Re: Clinton Landfill #3  
TSCA Permit Application

KPRG Project No: 10110

KPRG's project team performed a technical review of the geologic and hydrogeologic portions of applications filed for the Clinton Landfill No. 3 expansion in DeWitt County, Illinois. This review focused on the application for a chemical waste disposal facility within the footprint and airspace of the proposed expansion of the Landfill No. 3 facility. Our review has identified several issues that should be of concern to, and be considered by, the United States Environmental Protection Agency (USEPA) in reviewing the pending application. The following sections describe the proposed site and landfill characteristics, and detail concerns identified in our review.

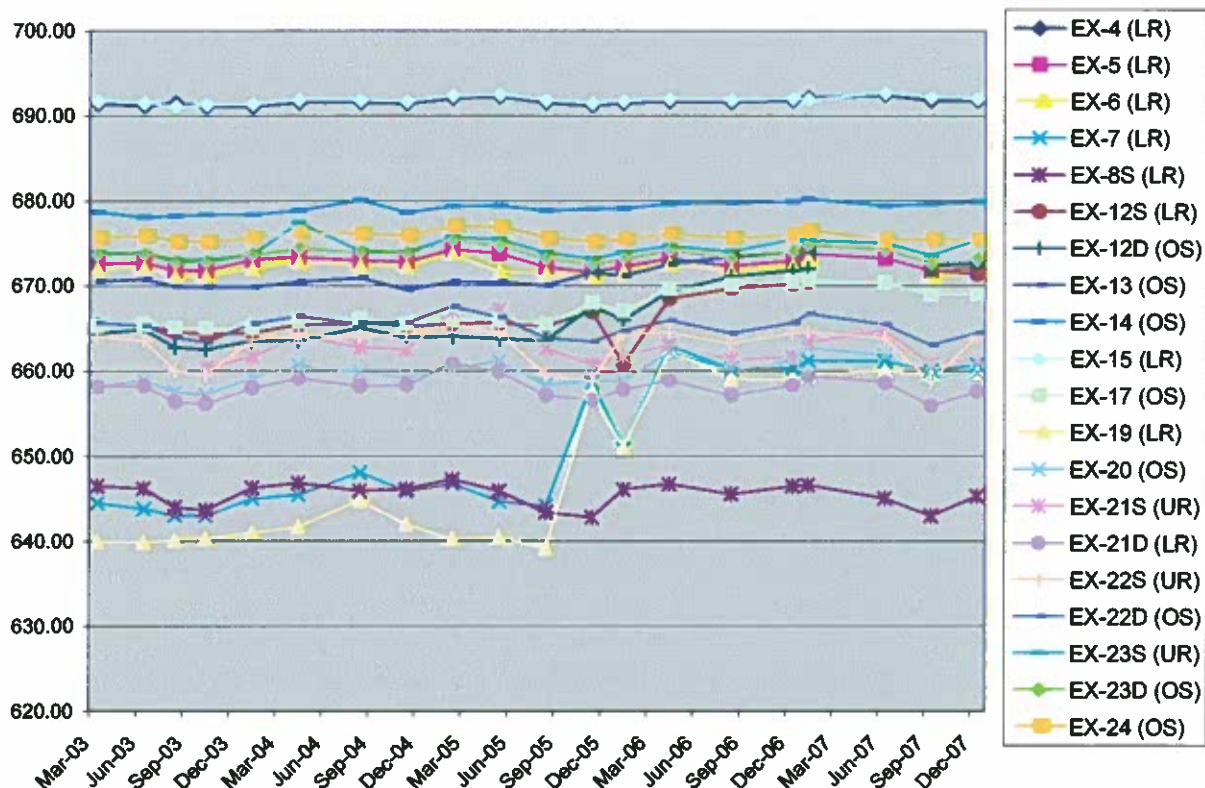
- **Insufficient Evaluation of Head Data** - Review of the groundwater head data supplied with permit application (see graph of heads below) shows that all monitoring wells located along the west and northwest boundaries of the Clinton Landfill (e.g., wells EX-7, EX-12S, EX12-D, EX-13, EX-17, and EX-19) for which head data was reported experienced rapidly rising heads commencing in late 2005 and 2006 while the remaining monitoring wells remained nearly static. This is an unusual occurrence that is completely unaddressed in the permit application.

To identify the cause of the increase in heads, readily available aerial photographs of the site were reviewed. It was observed that what appear to be storm water retention ponds, associated with construction on adjacent portions of the Clinton Landfill, had been constructed near the west and north perimeters of the permit area. If these ponds are the source of water causing the localized rise in heads, the glacial sediments when the proposed Chemical Waste Unit are capable of readily transmitting groundwater in a flow system that is significantly different than that described in the permit application. This casts doubt on the entire site characterization and resulting GIA in the Landfill application.
